**UNITED STATES
NUCLEAR REGULATORY COMMISSION**
REGION I
2100 RENAISSANCE BLVD., SUITE 100
KING OF PRUSSIA, PA 19406-2713

**SUBJECT: THREE MILE ISLAND STATION, UNIT 1 – NRC INTEGRATED
INSPECTION REPORT 05000289/2014004**

Report No: 05000289/2014004

Facility: Three Mile Island Station, Unit 1

Figure 1: All Profile Results for SGB

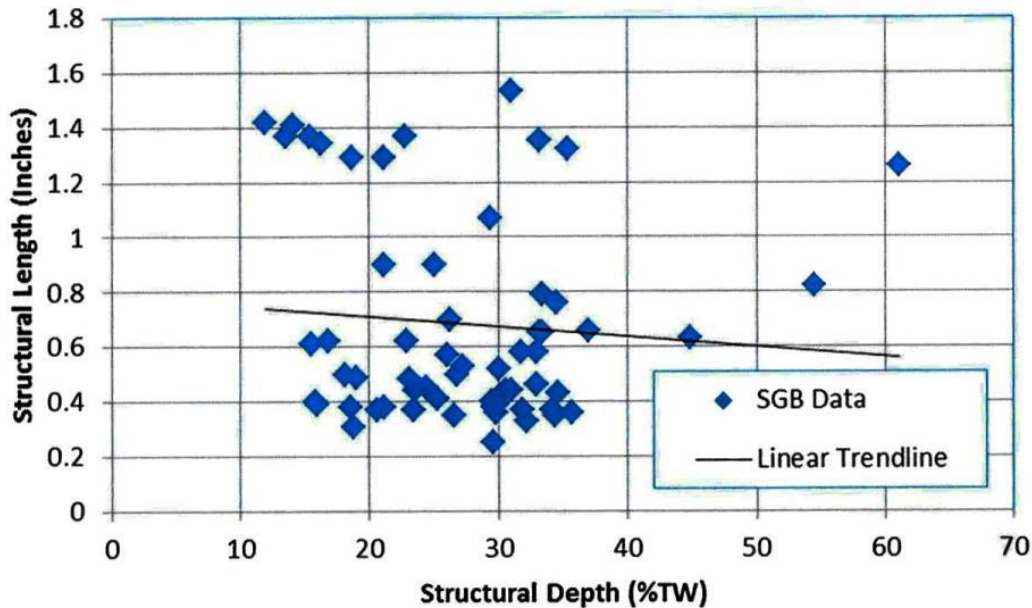
Question 9 - Was the eddy current data reviewed to establish whether or not larger structural lengths are biased toward being associated with deeper flaws? If so, what trends were observed?

Yes, there is a correlation between structural length and structural depth. However, this correlation is driven primarily by the shallow, tapered indications. To support the response to this question, additional line-by-line sizing was performed. This additional line-by-line sizing was focused on indications that the resolution analysts deemed to be flat as well as relatively shallow, tapered indications. This was done to complement the sizing that was performed during the outage which focused primarily on the deepest indications.

Figure 1 below shows the structural length plotted against structural depth for all profiled indications in SG B. As shown in the figure, there were twelve indications that were clearly flat as evidenced by a structural length greater than 1.2". Eleven of these twelve indications had structural depths less than 40%TW and six of these indications had structural depths less than 20%TW.

As shown in Figure 1, there is some correlation between structural length and structural depth. However, as previously mentioned, this correlation is primarily driven by the shallow, tapered indications. When a tapered flaw first initiates, it will only be present at one edge of the support and may only have a total length of 0.4", for example. Obviously, if the total length is 0.4" and the flaw is tapered, its structural length will be less than 0.4". As the flaw grows in depth, its total length and structural length will increase provided the taper angle remains the same. This is the primary reason that there is an apparent relationship between structural length and depth.
